## SERVICE INFORMATION NO. SI 36-115

SLICK Service Bulletin No. SB1-15A

**SUBJECT:** Potential decreased service life of Slick 4-cylinder magneto distributor gear assemblies. **Based on process and component improvements following the initial release of this service bulletin, the serial number range is being extended in this revision. Magnetos previously returned for compliance to SB1-15 must be returned or inspected for compliance to this revision SB1-15A.**

Figure 5. K3008 Distributor Gear With Monel Electrode

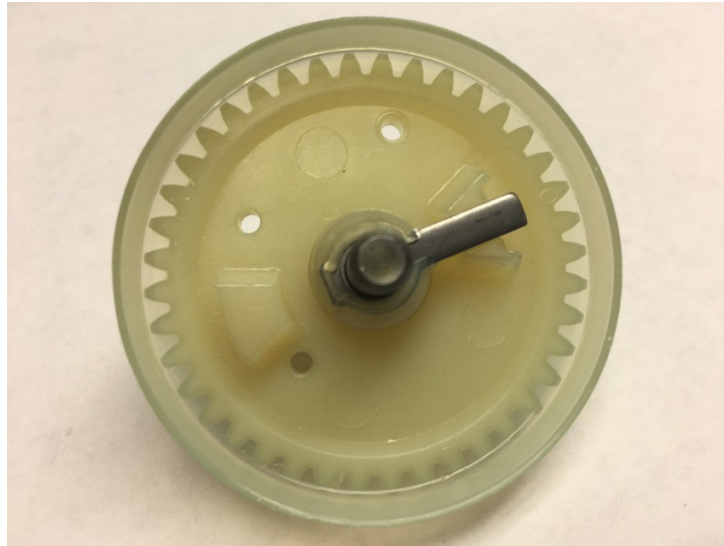
**If it is not possible to confirm the version of the distributor gear that is installed in a given magneto from maintenance records, the magneto may be removed from the engine in order to have the housing and distributor block removed to allow visual inspection of the distributor gear. Distributor gears with Copper electrodes must be replaced with distributor gears with Monel electrodes.**

REMOVE K3008 distributor gear assembly in subject magnetos and REPLACE with replacement K3008 distributor gear assembly **as soon as possible**, not to exceed the next 50 hours.
